CITY OF ALBUQUERQUE

**RE: Paseo Marketplace
Conceptual Grading Plan
Stamp Date: 3/2/17
Hydrology File: D18D056**

PASEO MARKETPLACE
CONCEPTUAL GRADING & DRAINAGE PLAN

C-1

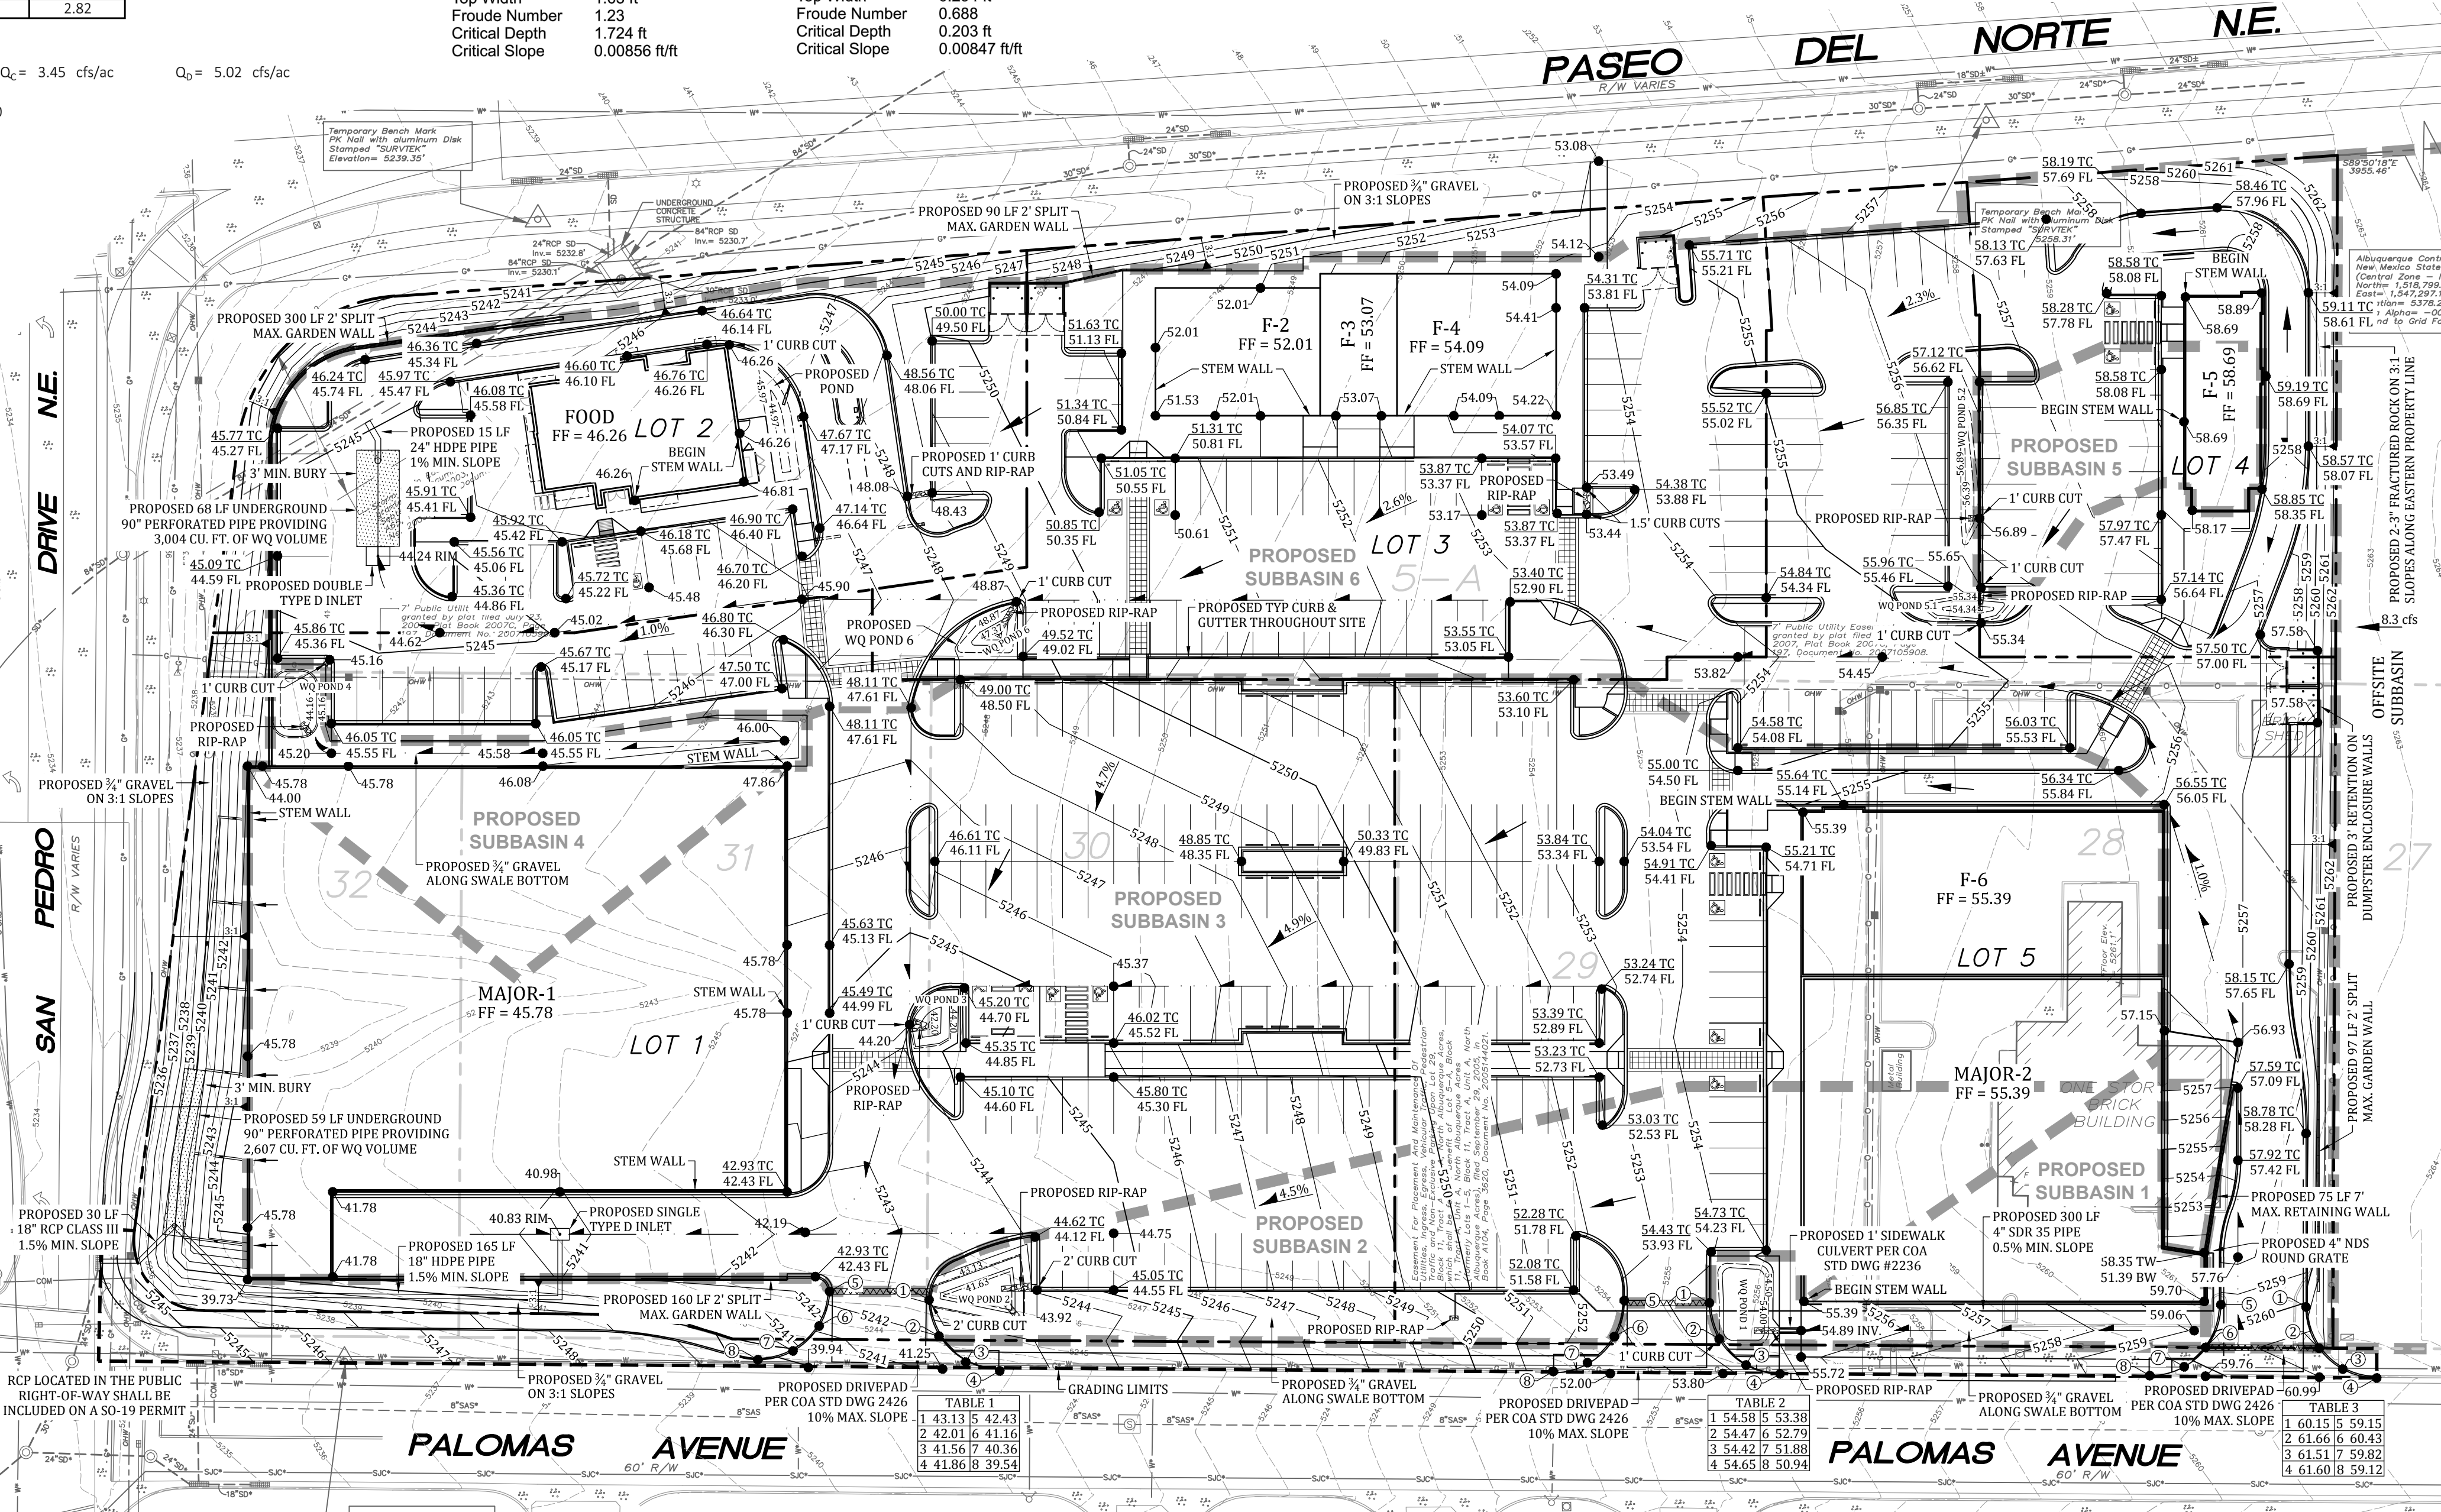
1. Discharge and connection into the 84-inch storm system needs the approval and a permit from New Mexico Department of Transportation prior to the City's approval. The contact information for District Three Engineer is Kenneth Murphy at 505-798-6630 and by email at kenneth.murphy@state.nm.us.

2. For your water quality pond for the subbasin 1, you are proposing a fire dept conn. for Bldg Major-2. Please shift this closer to the building and out of the water quality pond.

3. Under your Proposed Conditions, You make references to the 2015 FDS report and the historical runoff. This report references a RTI December 1991 Drainage Management Plan and a Wilson & Co. April 1991 Drainage Report. Both of these reports call for a future development of the undeveloped site (the above referenced project) as Treatment "D" 70% and Treatment "B" 30%. The Conceptual Grading Plan for the above referenced project shows Treatment "D" 89.5%, Treatment "B" 5.25%, and Treatment "C" 5.25%. I do not see any attempt to detain the difference in the treatment areas.

4. The proposed conditions section was a little hard to read. You might want to either add some space between the proposed subbasins or place all the information in a

separate 8 1/2 x 11 drainage report. This could also allow you to bring the site to a 1"=30' scale which would also make the Conceptual Grading Plan more readable as well.

5. For the proposed truck ramp, you call out a 4" NDS grate. I'm concerned about clogging of this inlet. Typically for a truck ramp, one places a French drain which can be easily cleaned out and if partially clogged, it will still function. You might want to take another look at this.
6. In Proposed subbasin 6, you have one building listed as Food. Just a reminder that for the drainage from the dumpster for this building will need to drain into the sanitary sewer.
